**Proposed Project for Application to the Kansas Department of Health and Environment
for the Kansas Water Pollution Control Revolving Loan Fund and to the Kansas
Department of Commerce for a Grant**

Applicant: City of McFarland
Wastewater Treatment System Improvements

Agency Review Comments:

RE: Environmental Review – McFarland, KS – Sewer System Improvements
NW ¼, Section 31, Range 11E, Township 11S

PROPOSED AREA FOR TREATMENT FACILITY EXPANSION

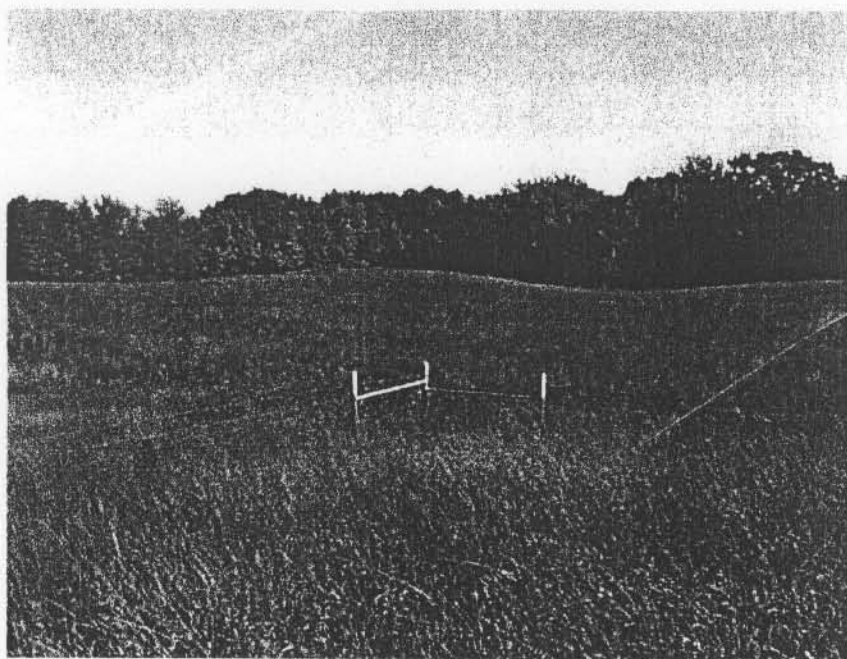
The proposed location for the third treatment cell appears to be close to a stream. It is possible that the depth to ground water may be shallow because of the proximity to a stream. Thus, it may be necessary either to construct a shallower cell with a larger area to meet the volume requirement or construct higher walls to the cell so as to keep the bottom of the third cell far enough above the ground-water table level to meet the KDHE regulations.
